# UNITED STATES PATENT AND TRADEMARK OFFICE

APPLICATION NO.	FILING DATE	FIRST NAMED INVENTOR	ATTORNEY DOCKET NO.	CONFIRMATION NO.
10/796,754	03/08/2004	Sun-Ha Hwang	4591-393	4368

**Office Action Summary**

## **DETAILED ACTION**

**Fig. 7**

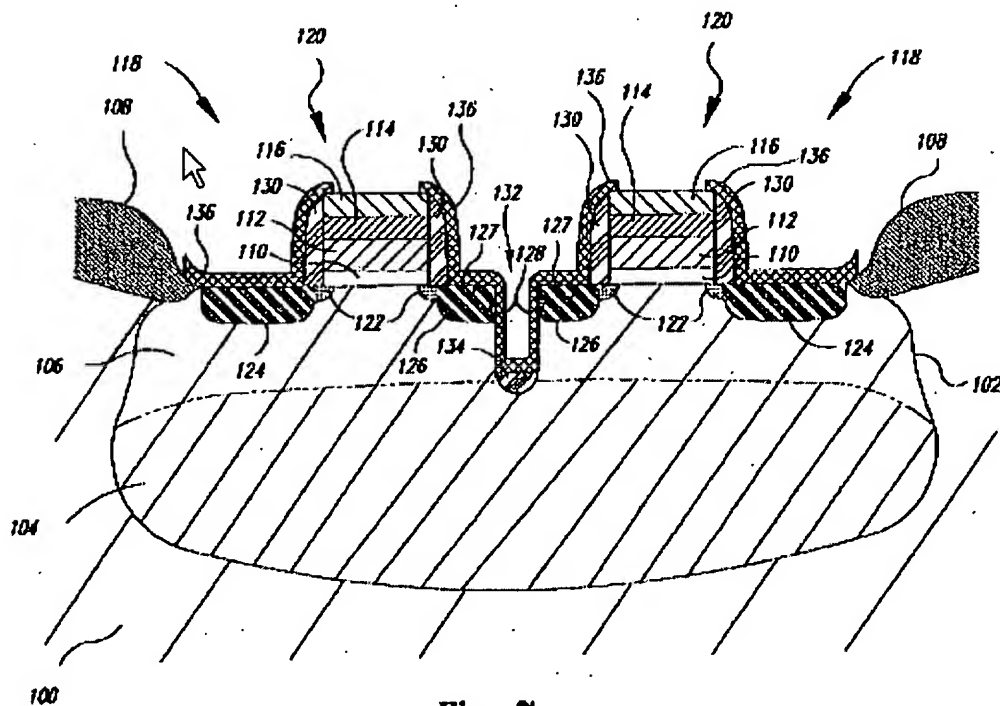
Violette disclose a semiconductor process as claimed. See FIG. 1-10 where Violette teaches the following

6. With respect to claim 5, Violette discloses that a method of fabricating a semiconductor device, comprising:

forming a device isolation layer **108** in a predetermined region of a substrate **100** of first conductivity type (doped P-type, column 3, line 10) to define an outline to an active region;

forming a gate pattern **120** crossing the active region;

forming a source/drain region **124 & 122** of second conductivity type in the active region (N-type, column 3, line 55) at both sides of the gate pattern;

patterning the device isolation layer (please note that it is well known to pattern the isolation region on a semiconductor substrate) and forming a recess that exposes a portion of the substrate of first conductivity type (please note that Applicant's claim language does not require the isolation regions to contain the recess), the portion exposed adjacent to the source/drain region of second conductivity type at one side of the gate pattern; and

siliciding **136** a surface of the source/drain region of second conductivity type and a surface of the substrate of first conductivity type exposed by the recess.
